## **PLANNING COMMISSION MEETING**

**Wednesday, August 19, 2026 at 6:00 PM**  
**Hamburg Township Hall Board Room**

**To:** Planning Commissioners  
**From:** David Rohr  
Planning and Zoning Director  
**Date:** August 19, 2026.

**Project address and Description:** Combined Site Plan Review (PZBA 26-0004) for a golf simulator/restaurant in an existing commercial building at 9704 Kress Road (TID 15-21-405-016). Project will include exterior renovations to commercial building and installation of new parking lot to the south. Applicant has requested waivers to the landscaping and parking requirements.

ARCHITECTURAL SITE PLAN

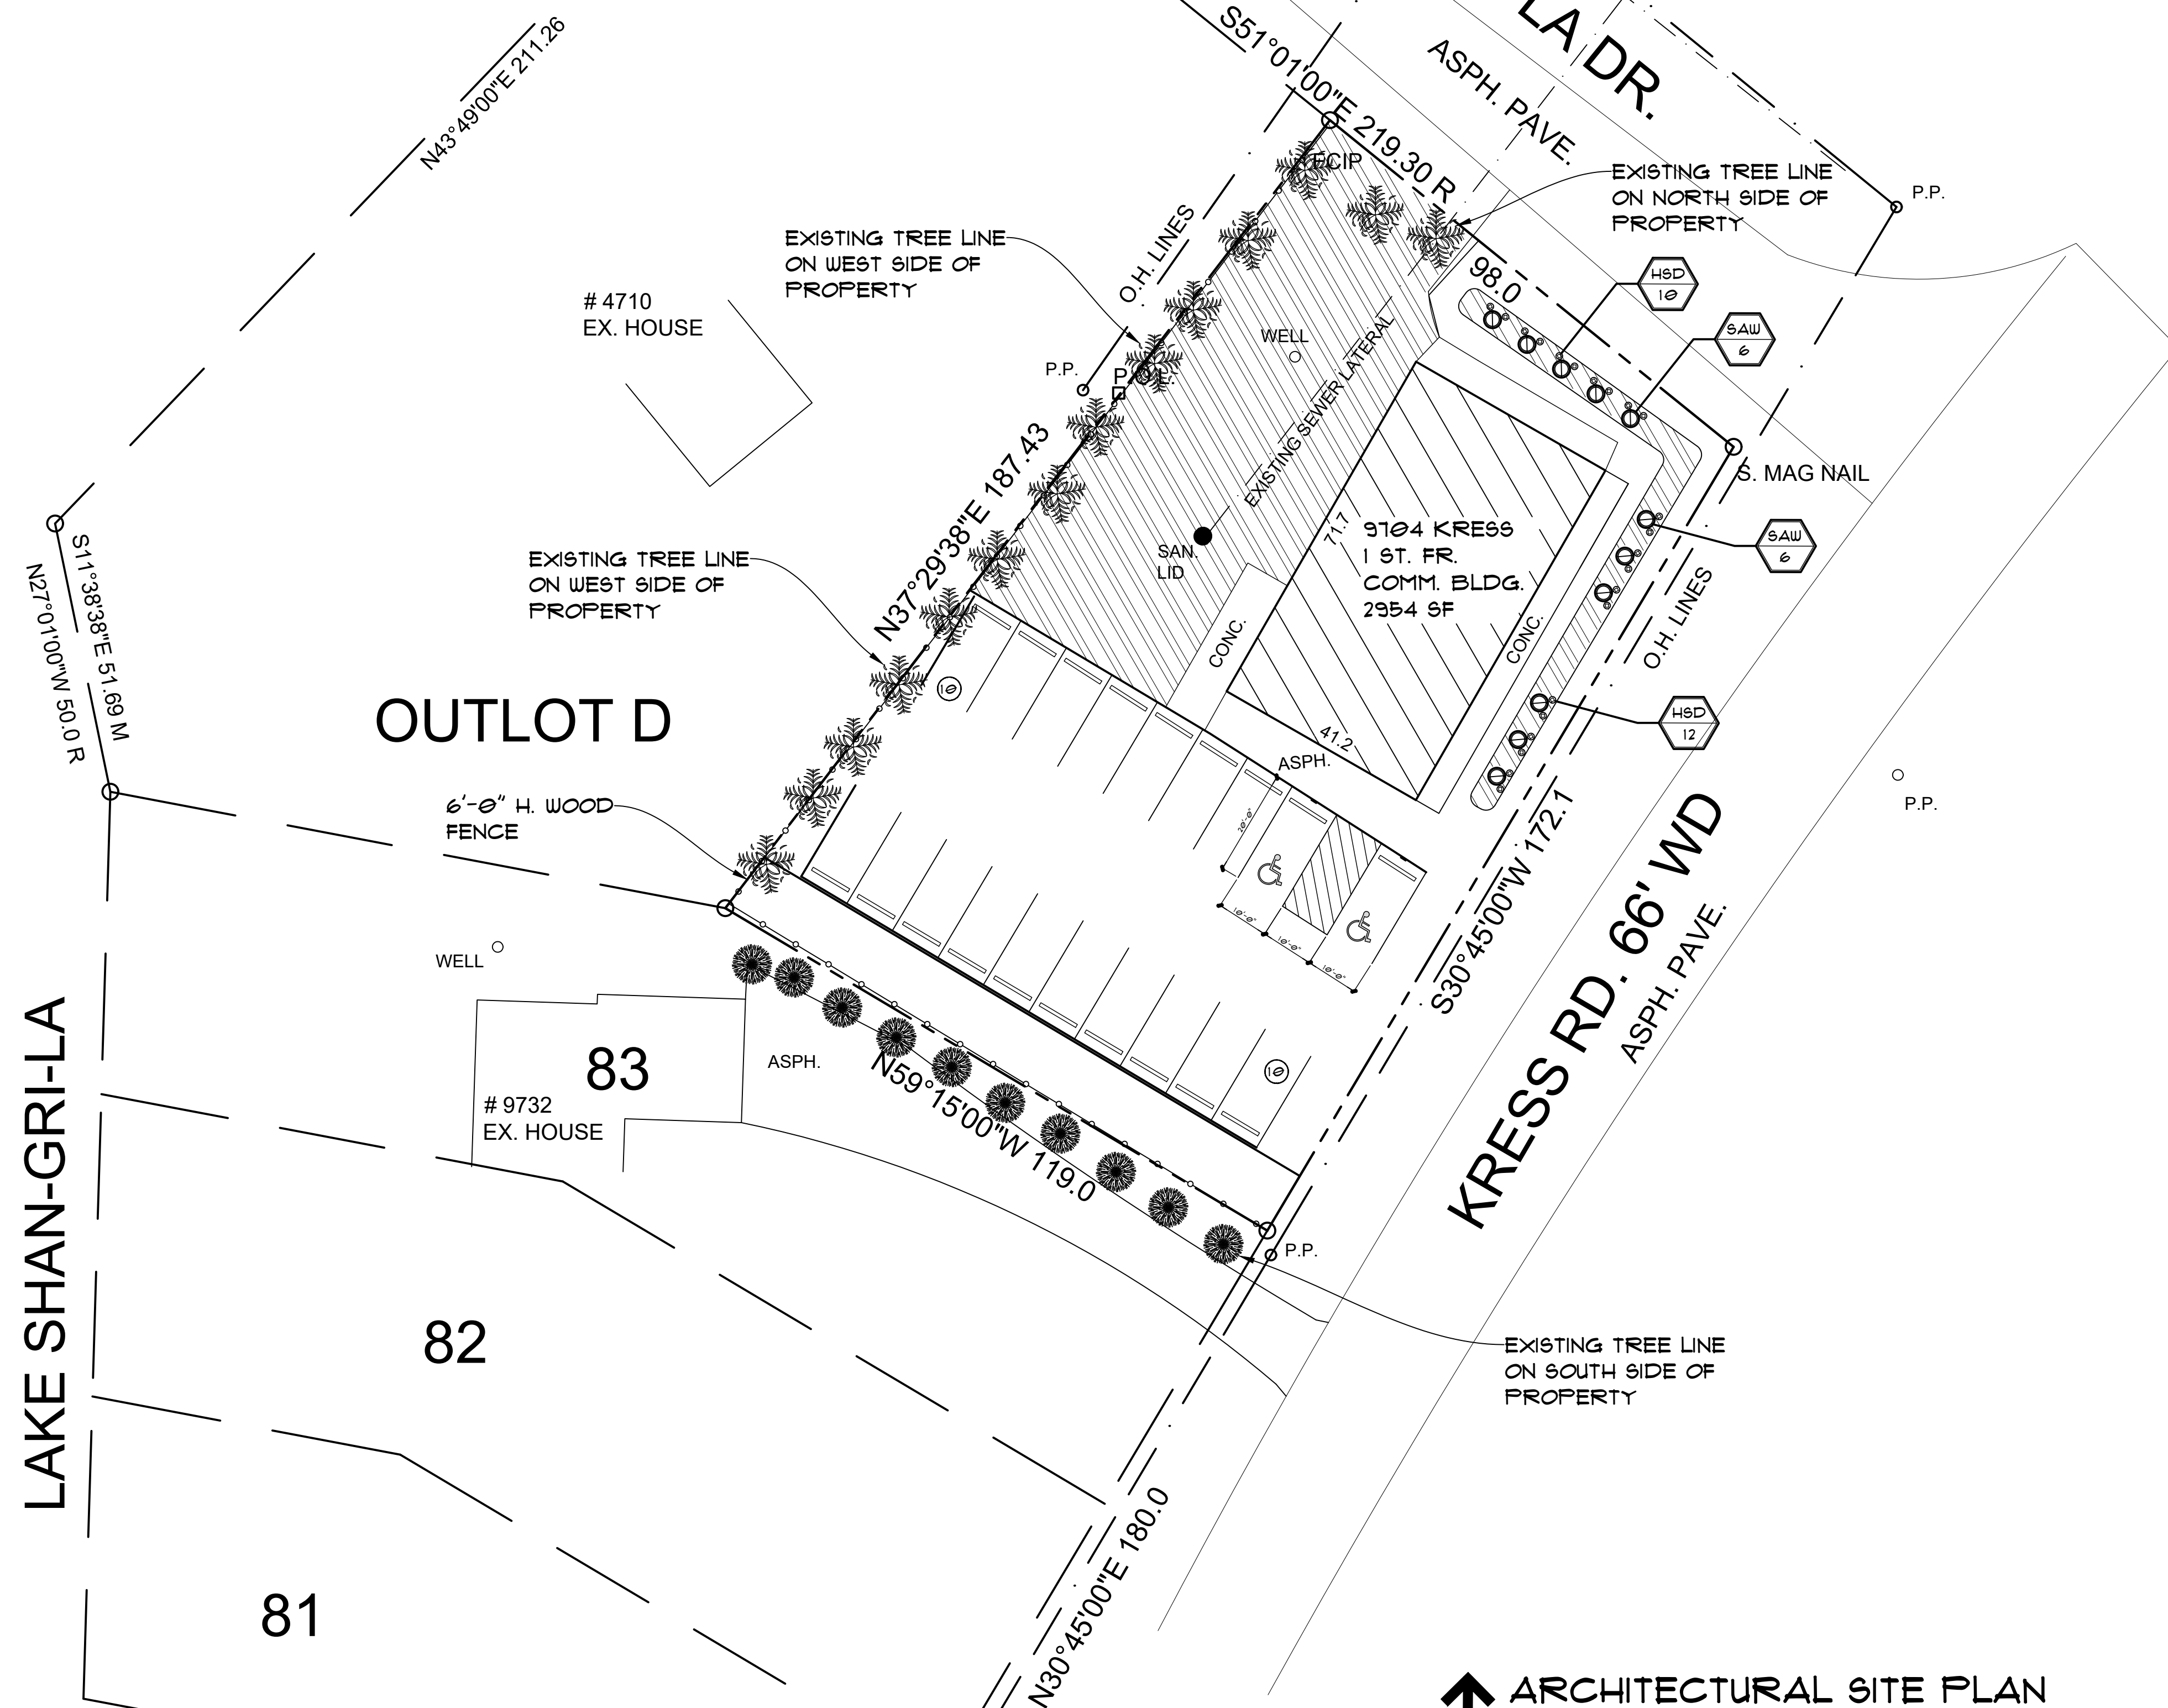
The current project submittal is substantially similar to the previously approved plan. The current proposal will not alter the building footprint. The proposed landscaping, parking, and storm water management will mirror the previously approved site plan. Based on the matching site plans, the applicant has decided to combine the preliminary/final site plan into one review meeting.

| Criteria/Regulation                                                                                                                                                                                                                                                                                                                                                                                                                                                                                                                                                                                                                                                                                                                                                                                                                                                                                                                                                                                                                                                                                                                                                                                                                                                                                                                                                                         | Required by Regulations | Proposed Project | Status                                                                                 |
|---------------------------------------------------------------------------------------------------------------------------------------------------------------------------------------------------------------------------------------------------------------------------------------------------------------------------------------------------------------------------------------------------------------------------------------------------------------------------------------------------------------------------------------------------------------------------------------------------------------------------------------------------------------------------------------------------------------------------------------------------------------------------------------------------------------------------------------------------------------------------------------------------------------------------------------------------------------------------------------------------------------------------------------------------------------------------------------------------------------------------------------------------------------------------------------------------------------------------------------------------------------------------------------------------------------------------------------------------------------------------------------------|-------------------------|------------------|----------------------------------------------------------------------------------------|
| <b>Staff analysis:</b> The parking plans conforms.                                                                                                                                                                                                                                                                                                                                                                                                                                                                                                                                                                                                                                                                                                                                                                                                                                                                                                                                                                                                                                                                                                                                                                                                                                                                                                                                          |                         |                  |                                                                                        |

| Criteria/Regulation                                                                                                                                                                                                                                                                                                                                                                                                                                                                                                                                                                                                                                                                                                                                                                                                                                                                                    | Required by Regulations                                                      | Proposed Project | Status                                  |
|--------------------------------------------------------------------------------------------------------------------------------------------------------------------------------------------------------------------------------------------------------------------------------------------------------------------------------------------------------------------------------------------------------------------------------------------------------------------------------------------------------------------------------------------------------------------------------------------------------------------------------------------------------------------------------------------------------------------------------------------------------------------------------------------------------------------------------------------------------------------------------------------------------|------------------------------------------------------------------------------|------------------|-----------------------------------------|
| <p>installation of such lighting shall be so hooded or shielded as to reflect the light away from abutting or neighboring property.</p> <p>6. When required off-street parking in a non-residential district abuts a residential district, there shall be located a landscaped buffer strip fifteen (15) feet wide and parallel to the mutual boundary. The buffer strip shall be composed of trees and/or foliage. In lieu of a buffer strip, the Planning Commission may permit or require a solid fence or wall between six (6) and eight (8) feet in height shall be located along the mutual boundary.</p> <p>7. Federal and State requirements regarding handicapped parking and access shall apply.</p>                                                                                                                                                                                         |                                                                              |                  | <p>Waiver requested</p> <p>Conforms</p> |

**Condition 1:** A 6-foot-tall solid fence along the west and south property boundary to lessen the impact from this project on the residential use to the west shall be installed, with the required shrubs planted on the west side of the fence. Trees and shrubs shall be installed in the west yard adjacent to the building. Fence details have been provided.
